## Planning Commission Vote Report

**Petition:** **PZ 12-2020 The Residences at Hog Hollow (14001 Olive Blvd):** A request for a change in zoning from R-3 Residence District to PUD Planned Unit Development for a maximum of 100 residential units (16R340151).

Re: P.Z. 12-2020 The Residences at Hog Hollow, 14001 Olive Blvd., City of Chesterfield, MO -  
Response Letter to Comments Dated 12/16/2020 (Stock Project No. 219-6568)

**Two(2) Photos of Existing Chain Link Fence Along  
West Property Line of Chesterfield Management  
Associates, LP & East Property Line of Keymer  
Realty & Investments LLC**

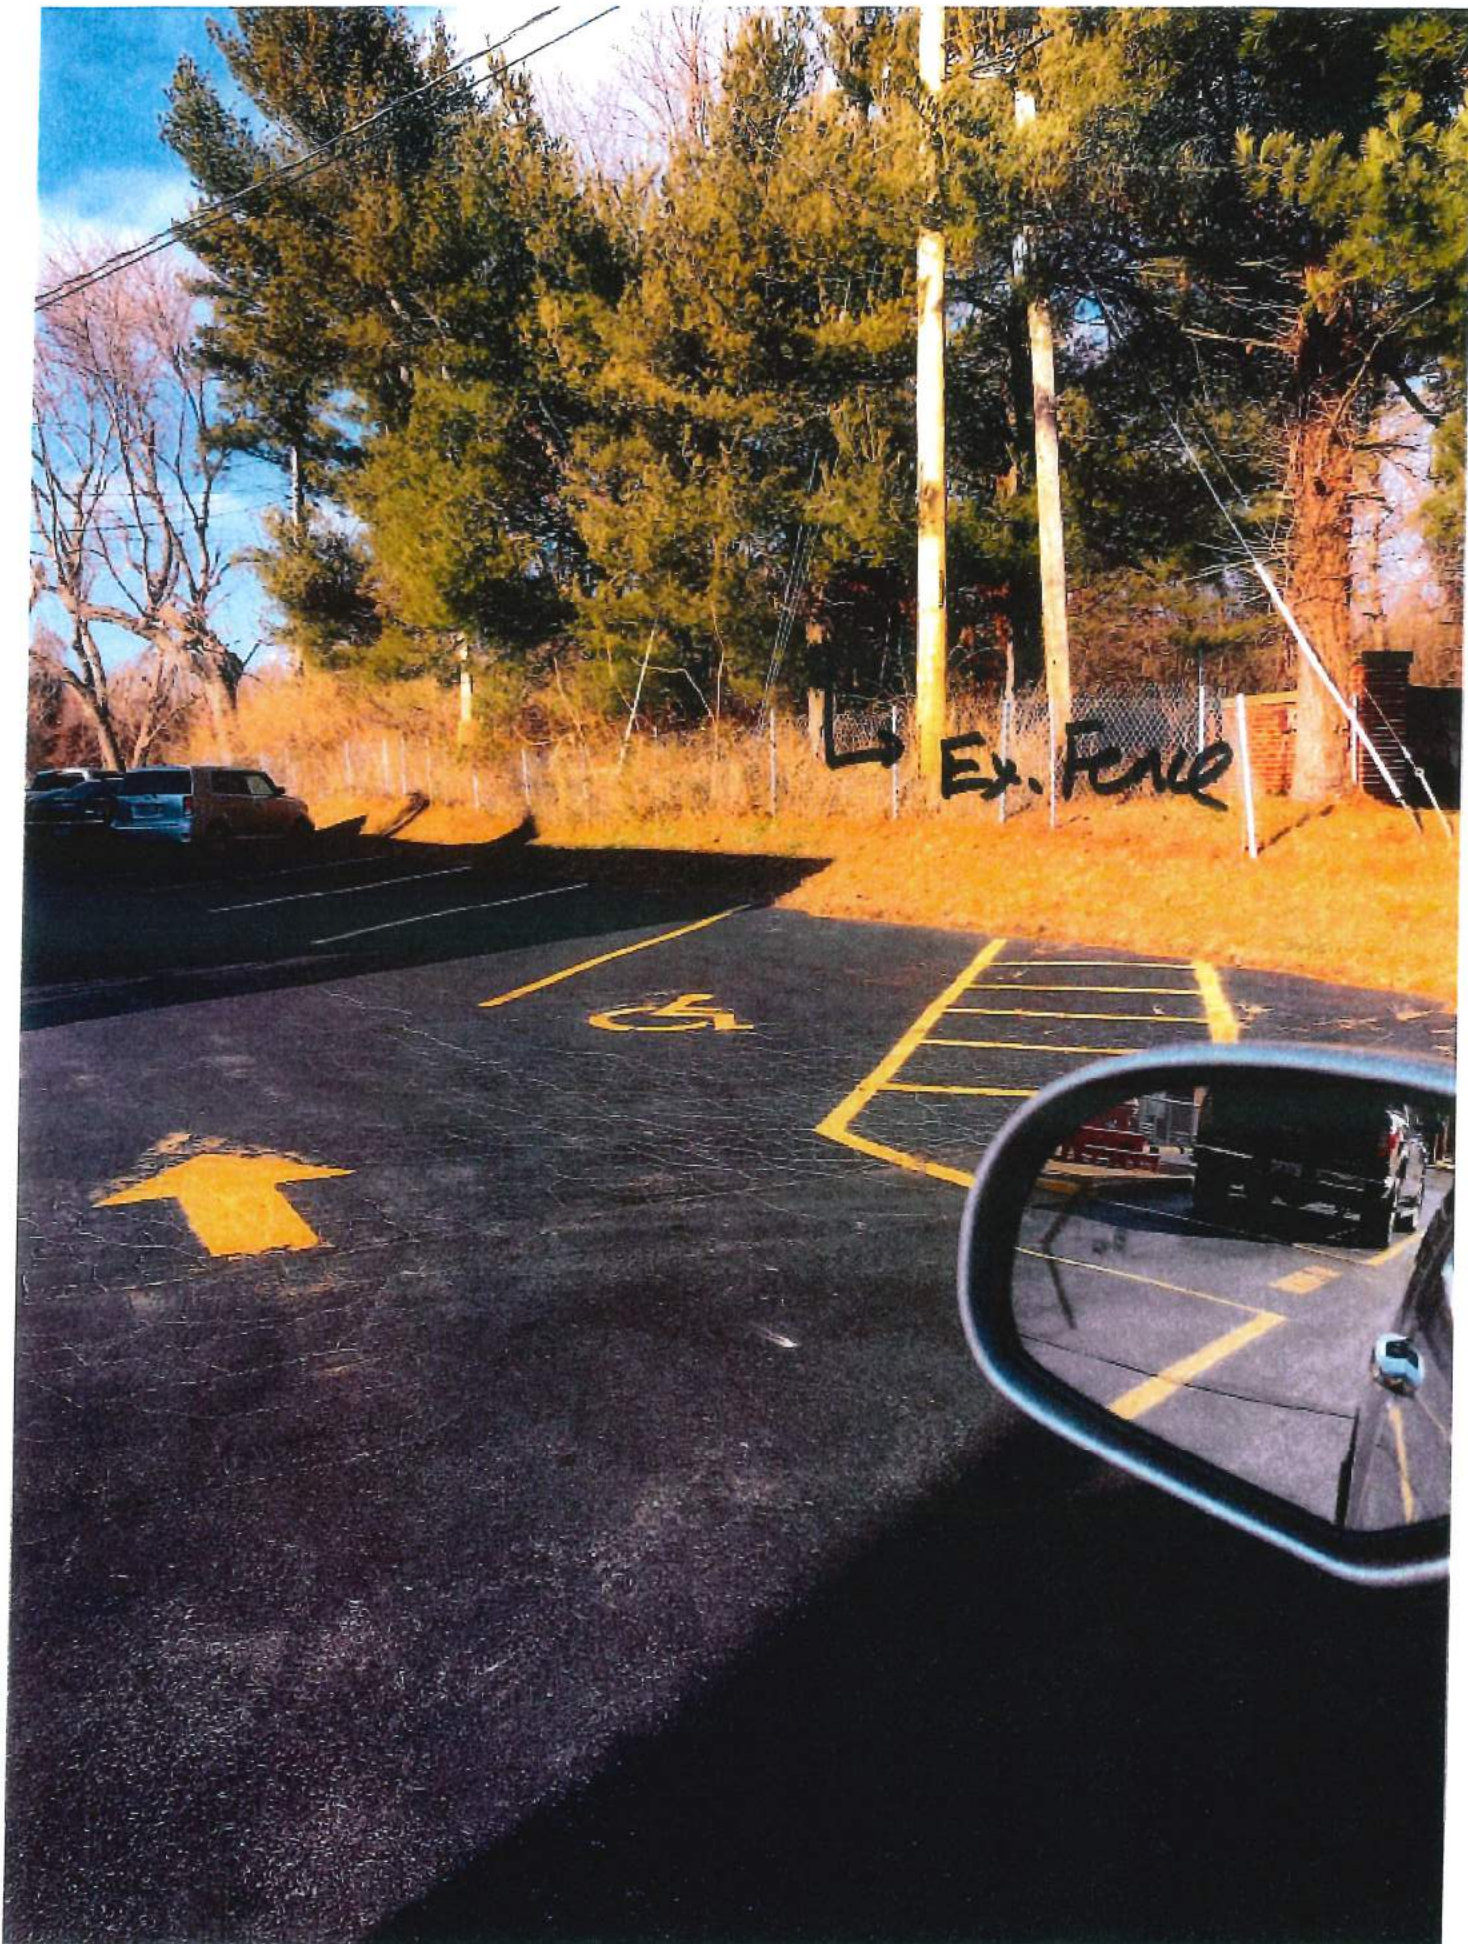
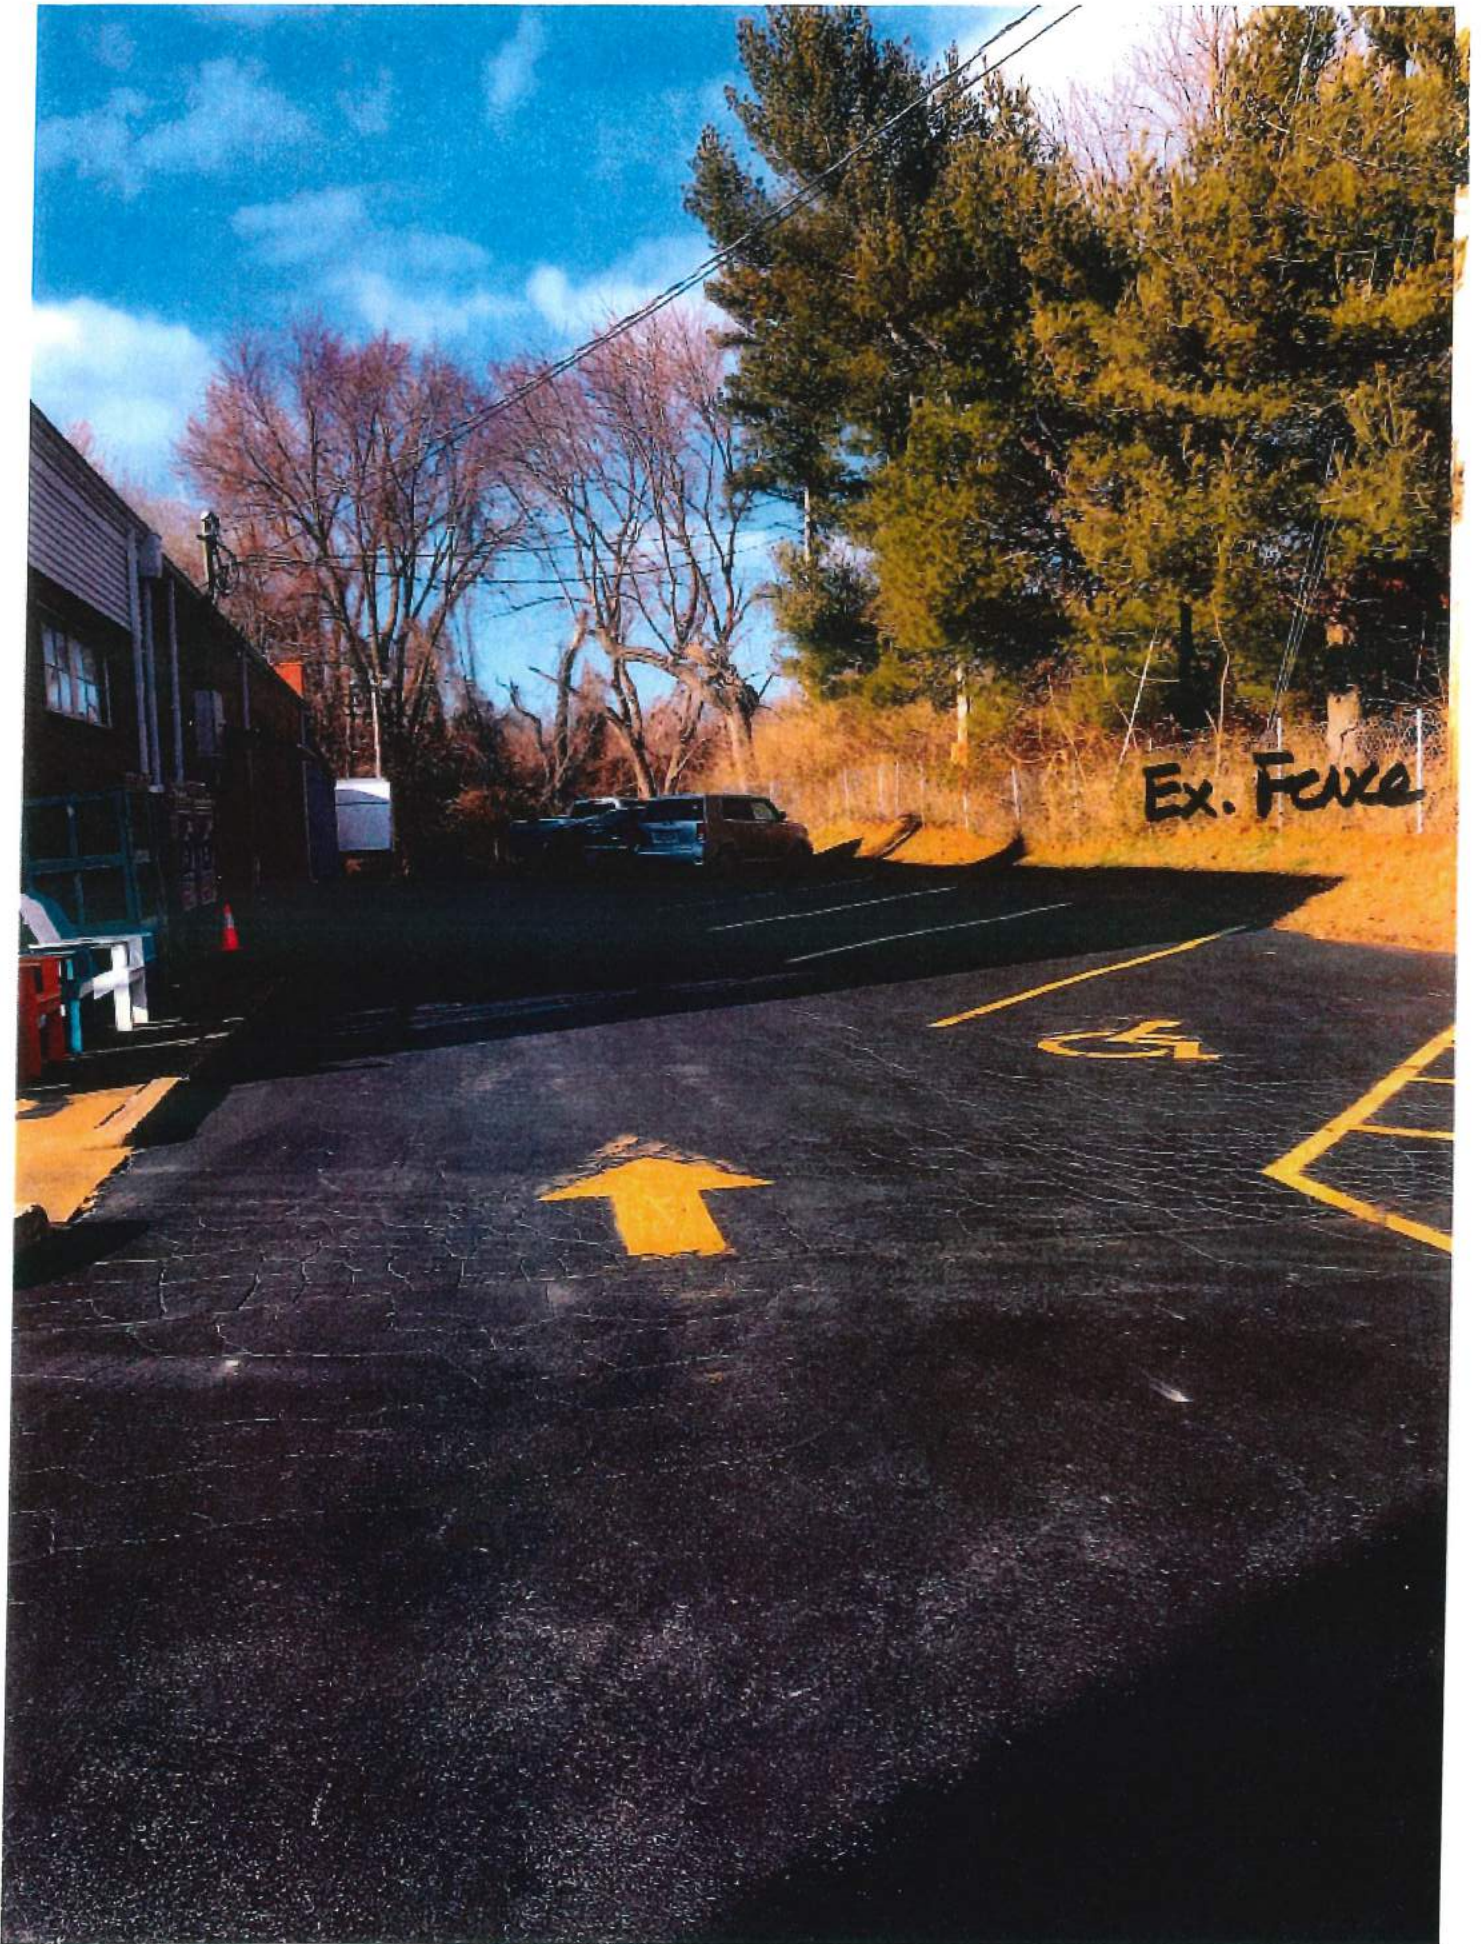
3. 14015 Olive Boulevard: There were several items discussed relating to 14015 Olive Boulevard:
  - a. Fencing: The property owner of 14015 Olive Boulevard requested a fence in order to screen his property from residents of the proposed development. In ensuing discussion, it was noted that there may be difficulties with sight distance should the fence be installed on the eastern boundary of 14015 Olive Boulevard, along the proposed entry road to the development. Provide information on the fence and depict on the Preliminary Plan.

**Response: A sight proof fence is not a requirement of the 30-foot Landscape Buffer. The Landscape Buffer will be planted and maintained by the Home Owners Association in Accordance with City Code and an approved Site Development Plan. The Owner/Developer of the Residences at Hog Hollow is "Not Opposed" to the adjoining property owner (Keymer Reality & Investments, LLC) installing and maintaining a sight proof fence on their property, today a chain link fence exists between the two (2) properties (photos attached).**

**One (1) Photo of Existing “LPG” Tank & 2005 Survey  
Showing Location on the 14015 Olive Blvd. Property**

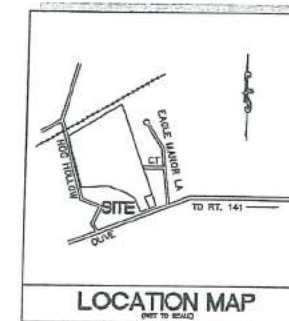
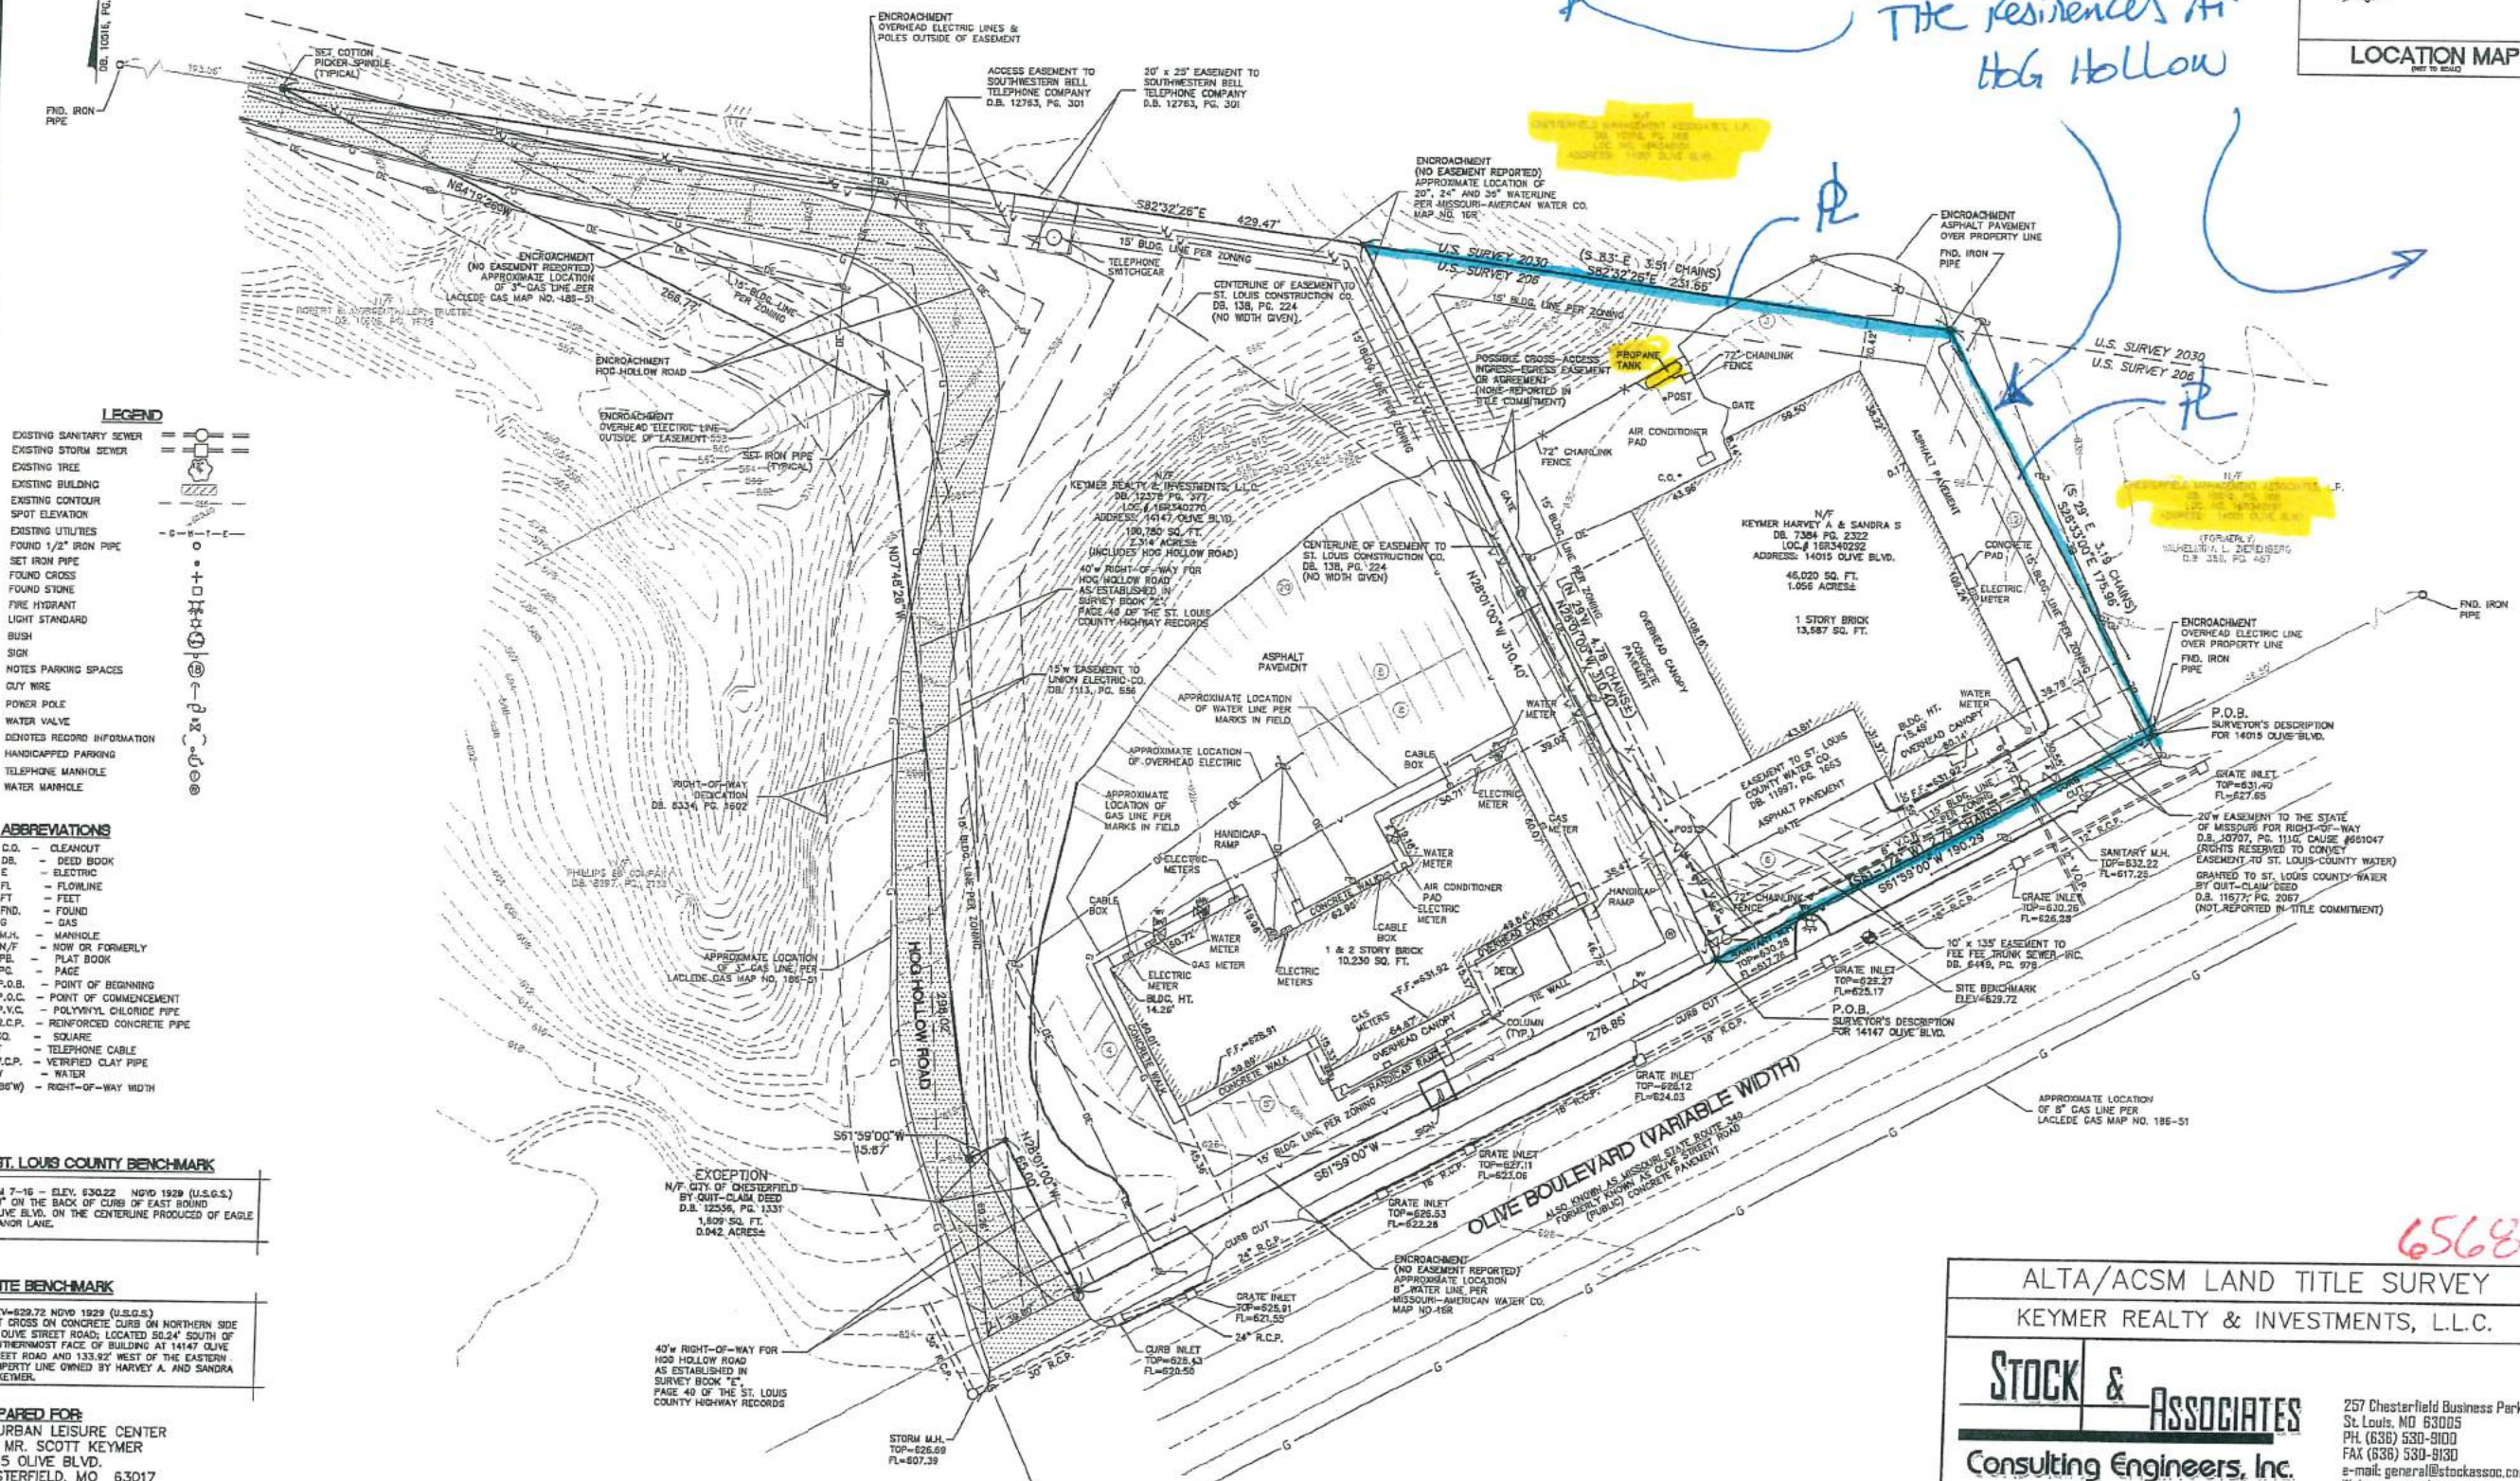
- b. Propane tanks: It was noted that there may be safety issues with the propane filling that occurs at 14015 Olive Boulevard and maintaining adequate distance between the propane tanks and any structures proposed in this development. Provide information on the required safety distance between propane tanks and structures.

**Response: The Owner/Developer of the Residences at Hog Hollow believe that it is the responsibility of the property owner & operator of the existing Liquefied Petroleum Tank to operate in accordance with all City, County, State, Federal, & OSHAA Guidelines. Attached is information from St. Louis County Department of Public Works & The Monarch Fire District regarding the LPG Tank. Attached is a 2005 Survey & Current photo of the tank's location on the 14015 Olive Blvd. Property.**
